Access Compliance Report

Public Rights-of-Way

(Curb Ramps)

Intersection ID: 50634	Main Street: BLUE_JASPER_RD	Cross Street: CORAL_ROSE_RD	Location: SW
ADA ID: 20ECE57C7BC1	Ramp Type: Perp	Initial Pass/Fail: Fail	Overall Compliance: No
		Severity Score: 12.5

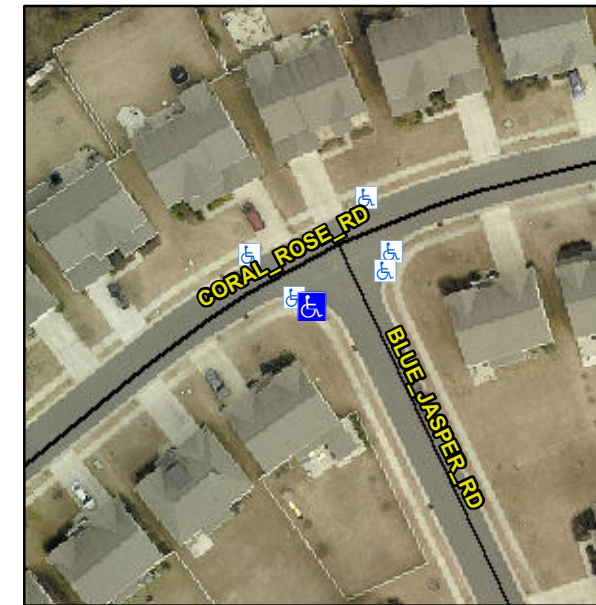
Not Found, R304.5.3

Compliance	Description	Data	Compliance	Description	Data
N/A	Ramp Length (in)	45.5	Yes	Ramp Slope (%)	7.8
Yes	Ramp Width (in)	48.0	No	Ramp XSlope (%)	6.0
N/A	Flare Type LT	N/A	N/A	Flare Type RT	N/A
N/A	Flare Slope LT (%)	N/A	N/A	Flare Slope RT (%)	N/A
N/A	Flare Traversable LT?	N/A	N/A	Flare Traversable RT?	N/A
N/A	Landing Length (in)	N/A	N/A	DWS Provided?	N/A
N/A	Landing Width (in)	N/A	N/A	DWS Contrast?	N/A
N/A	Landing Slope (%)	N/A	N/A	DWS Length (in)	N/A
N/A	Landing X Slope (%)	N/A	N/A	DWS Full Width?	N/A
N/A	Landing Curb? (Y/N)	N/A	N/A	DWS Offset (in)	N/A
N/A	Shared Landing?	N/A			
N/A	Gutter Ponding?	N/A	N/A	Gutter Slope (%)	N/A
N/A	Gutter Lip Ht (in)	N/A	N/A	Gutter X Slope (%)	N/A
N/A	Painted X Walk1?	No	N/A	Painted X Walk2?	N/A
	X Walk 1 Direction	To NE		X Walk 2 Direction	N/A
N/A	X Walk 1 Width (in)	N/A	N/A	X Walk 2 Width (in)	N/A
	X Walk 1 Slope (%)	0.6		X Walk 2 Slope (%)	N/A
	X Walk 1 X Slope (%)	3.6		X Walk 2 X Slope (%)	N/A

Remove & Replace Entire Ramp.
